JUSTIFICATION

107 HIGH STREET, LINDFIELD, HAYWARDS HEATH, RH16 2HR

Technical section through first floor illustrating overlaid oak flooring

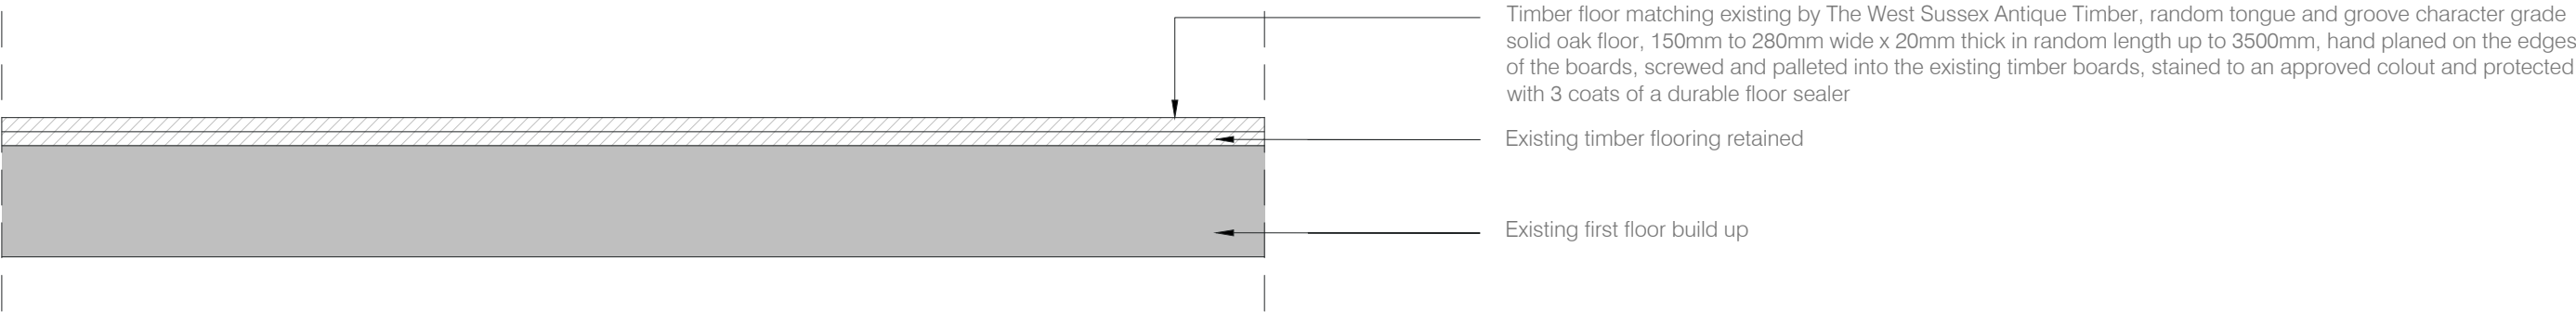
The first floor floorboards have been retained in-situ and have received new overlaid floor finish that very closely matches the existing timber floor finish found elsewhere in the house, specifically on the ground floor. High quality seasoned oak plants of varying widths and lengths have been supplied and installed by The West Sussex Antique Timber Co. Ltd. The boards are in-keeping with the character of the house and do not contribute or cause any loss of historic fabric. According to the supporting HCUK heritage statement, this change is considered to be of neutral impact to the significance of the listed building
